Subject: Application Site Plan Approval and Conditional Use Permit
Proposed Gateway Hotel Complex
Oberlin College
7 North Main Street

Date: November 27, 2013

REVISED BUILDING PLAN SUBMITTAL

DATE: 11/22/2013
TO: GARY BOYLE, AICP DIRECTOR OF PLANNING AND DEVELOPMENT, CITY OF OBERLIN, OH
FROM: CHRISTOPHER NOBLE
CC: R. WATTS, T. REED, OBERLIN COLLEGE
RE: OBERLIN COLLEGE GATEWAY BUILDING – REVISED BUILDING DESIGN

C5.0

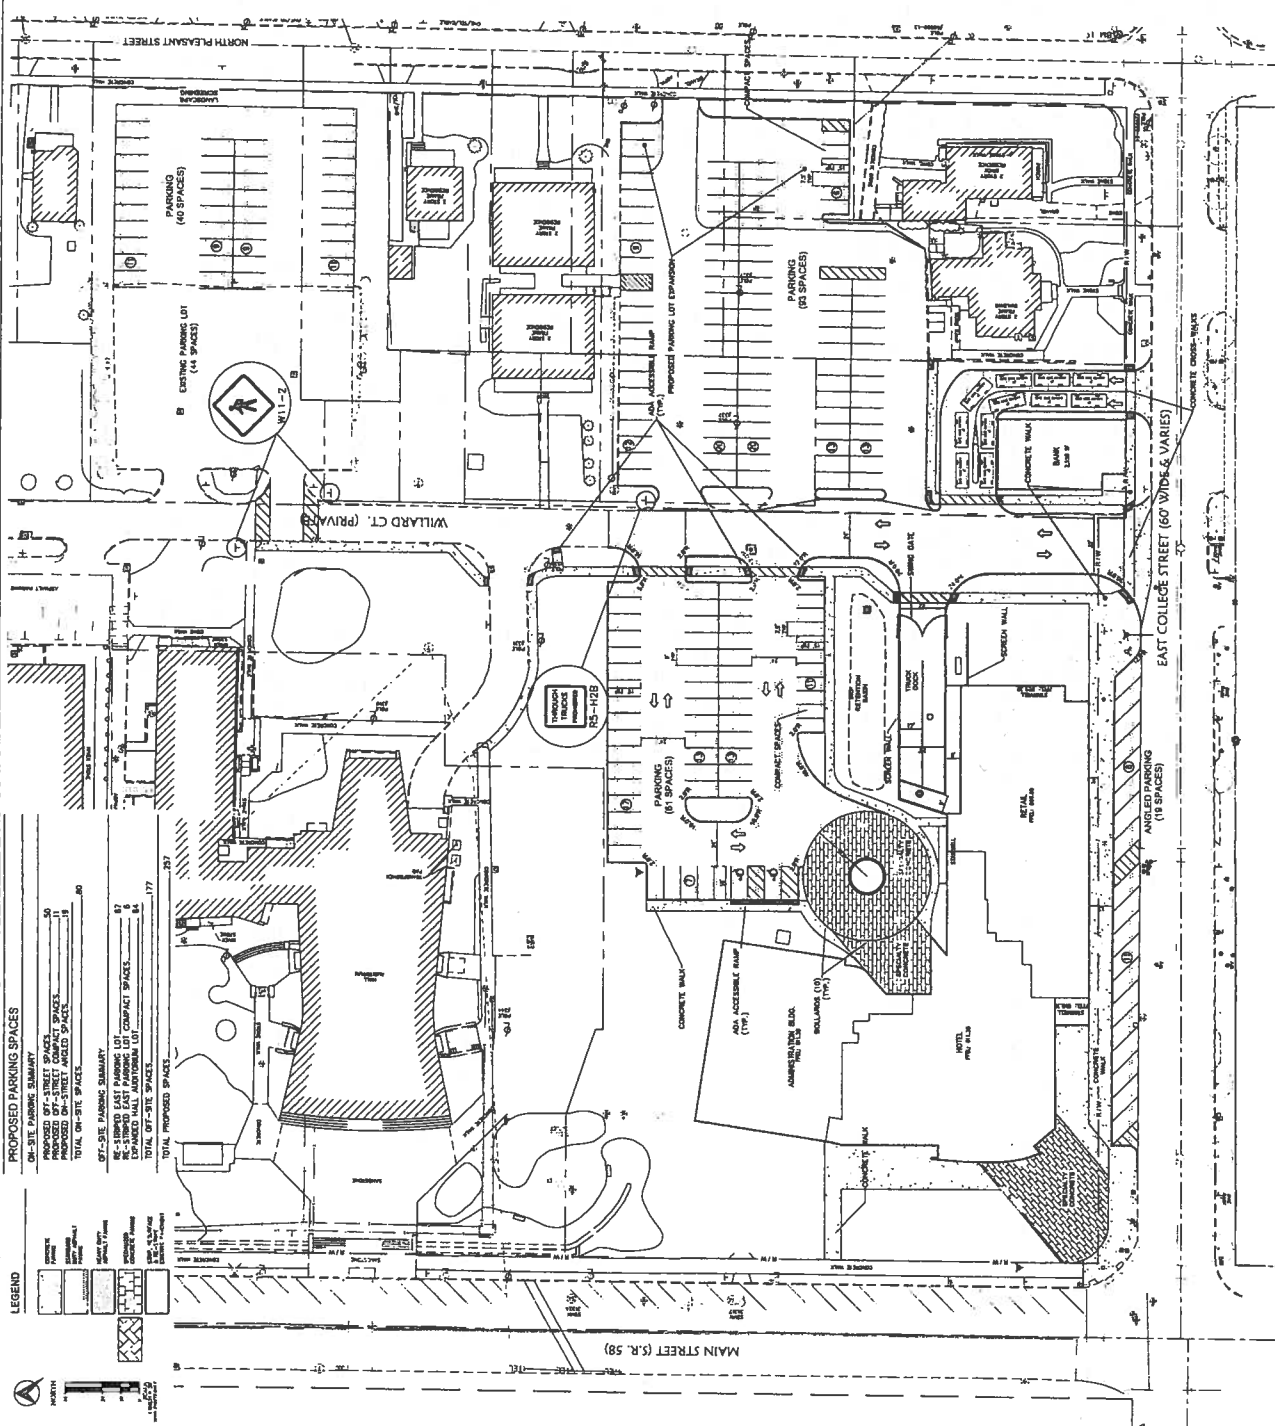
2. That a revised site plan design indicating a relocation of the proposed bank building to the north, and the proposed bank drive-through lanes connecting with "Parking Zone B" be submitted for the final review and approval of the Planning Commission.

4. That the proposed building design for the hotel complex reflect an accentuated main hotel entrance near the intersection of Main and College Streets as required by the City's adopted design standards and guidelines.

5. That the proposed building design for the hotel complex reflect compatibility with downtown building architecture, materials and colors as required by the City's design standards and guidelines.

ENLARGED LANDSCAPE PLAN
GATEWAY BUILDING
 Oberlin College

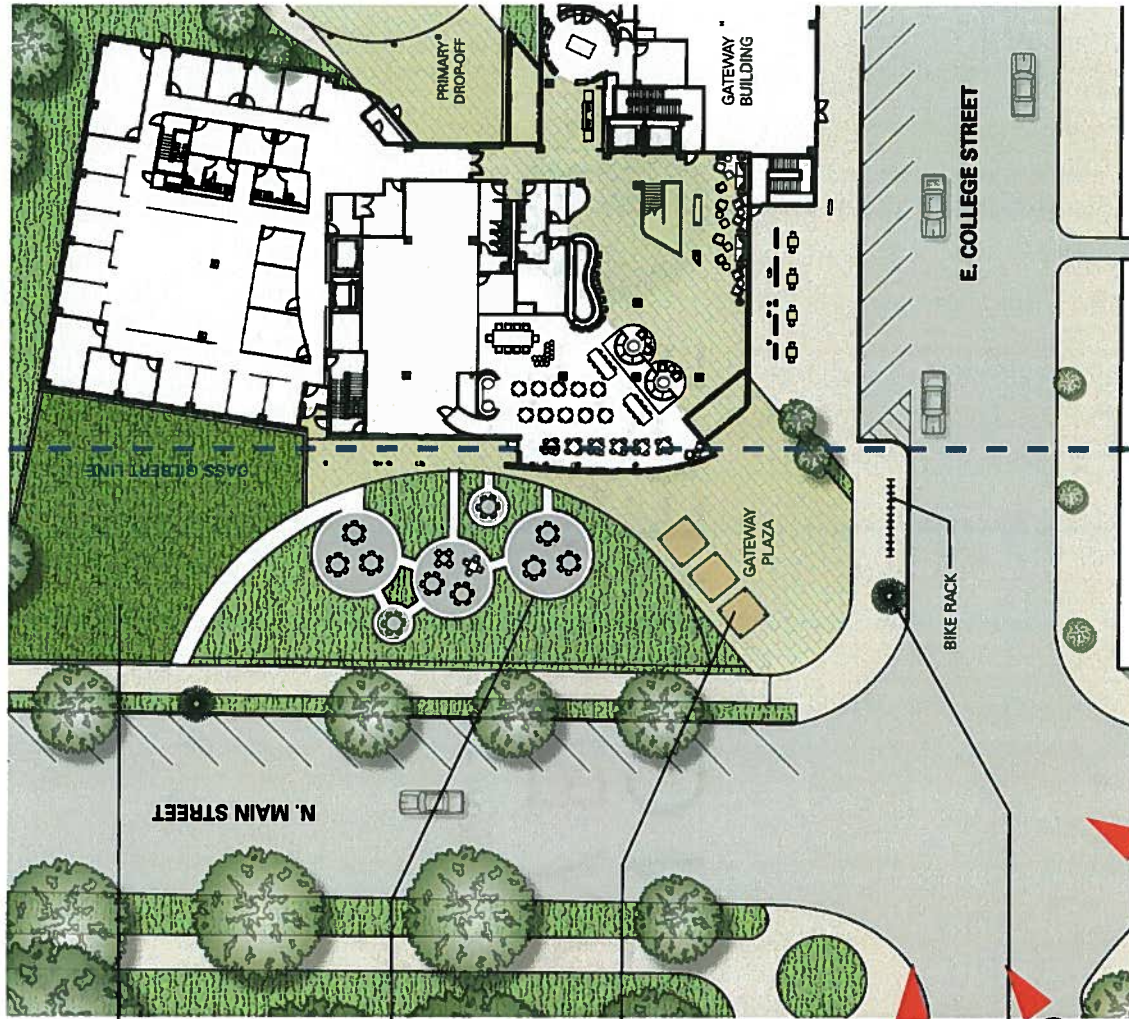
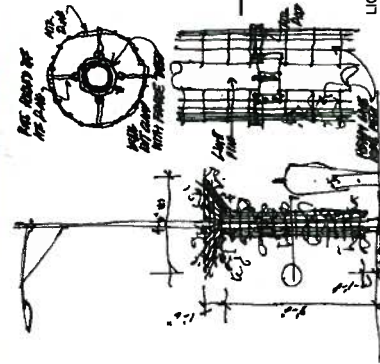
Staff further notes that the use of the proposed outdoor activity area or “outdoor café” area in front of the building along North Main Street will require the submission of an application for a “Conditional Use Permit,” and the review and approval of the same by the Planning Commission.

- The setback area in front of the building entry hardscape includes the opportunity to provide seasonal and or temporary event/vendor and or programmed activities, pooling pedestrians.

- Moreover the area is an ideal location for public art installations and performing artists.
• The dining/soft/landscape area of the setback is conceived as a group of dining “pods” – paved areas naturally organized in the landscape, which provide activity in the setback while simultaneously allowing strong pedestrian connection to the sidewalk along Main Street, which is unlike the condition as it exists at the Inn today.

**PERSPECTIVE
GATEWAY BUILDING**
Oberlin College

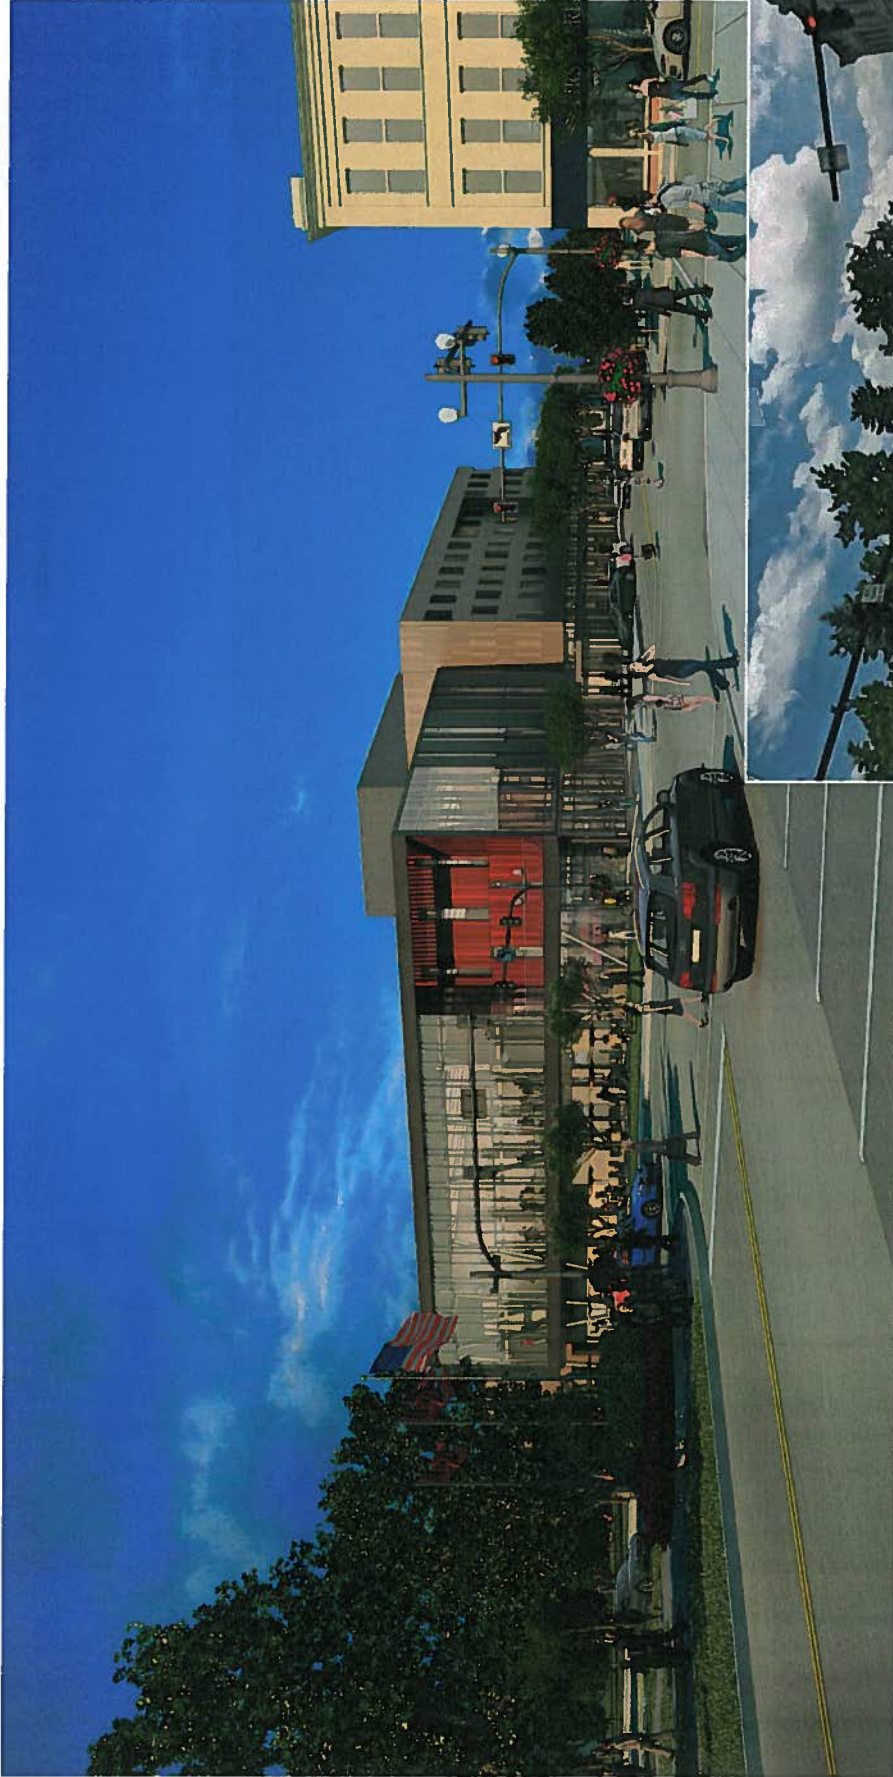
Staff notes that the applicant’s “revised” building plan submittal includes some modification to the building’s entry oriented toward the intersection of College and Main Streets, the use of some sandstone material on the building’s first floor façade on Main Street, additional window openings on the second floor balcony area, the use of a darker tone for aluminum panels, an indication of the design/landscaping of a proposed activity area in “front” of the building along North Main Street, etc.

- The original entry corner “fin” /angled column has been eliminated. This more fully opens the entry, both physically to pedestrians as well as visually. Two thin V-shaped columns take the place of the angled column.

- The amount of glazing has increased around the entry to provide greater visual connection between the inside and outside of the building in the areas adjacent to the entry doors.

- The ballroom window system wraps into the Event Room terrace on the second floor above the entry to provide a panoramic view of downtown. This opening up of the façade increases the sense of monumentality at the entry and simultaneously, by eliminating a blank façade element, more clearly pronounces “front”.

- On the Event Room terrace over 50 sq ft of added windows punctuate the Oberlin red wall material and decrease its overall mass and appearance. We feel that the splash of traditional color that remains is a critical balancing and enlivening element of the design.

GATEWAY BUILDING
Oberlin College

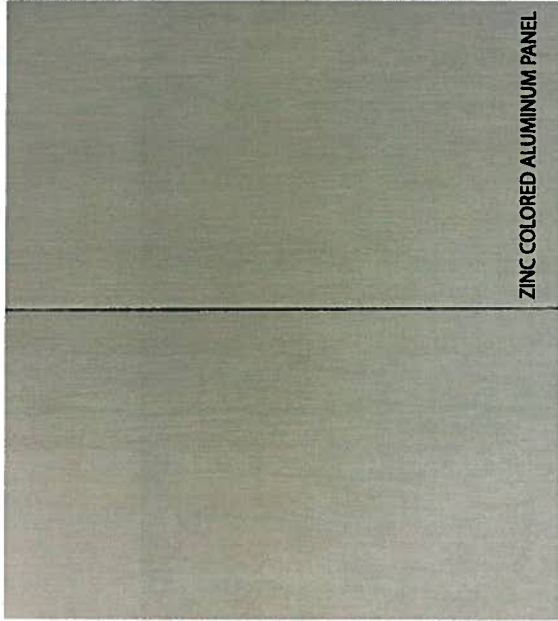
- Sandstone has been added to the west/restaurant outdoor dining plaza façade in lieu of the okoskin material. The specific stone we are proposing is called Birmingham Buff and is quarried by Cleveland Quarries in Lorain County.
- The metal panel material has been simplified and changed to a zinc patina aluminum panel which has a much warmer tone and feel than the metal panels we previously specified. It will be quite different and unique compared to other metal panels on campus, while still being contextual and in alignment with Oberlin’s aluminum heritage.
